PRODUCT UPDATE

Written by | Applications Engineer | June 10, 2019 | #211

Grounding Tag Modification for ERN.1B with PCB Contacts

ERN.1B.3__.GLN

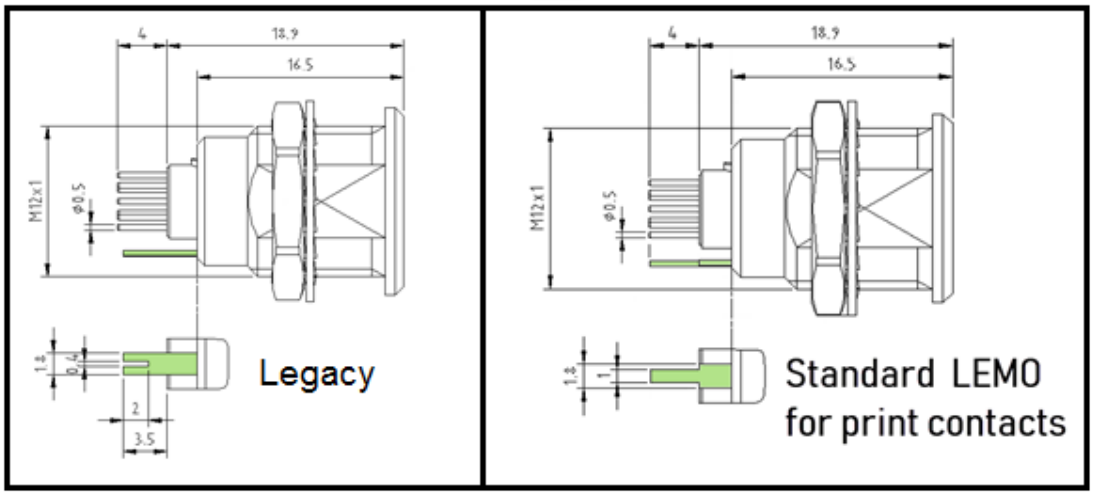
The grounding tag for the ERN.1B models with PCB contacts has been modified.

In order to standardize the product line, the grounding tag for PCB contacts will now be supplied with a stinger tag rather than a slotted tag. The slotted tag will be used for solder bucket and crimp terminations, and the stinger tag for PCB terminations.

The modified grounding tags for ERN.1B models with PCB contacts will begin shipping for any new orders.
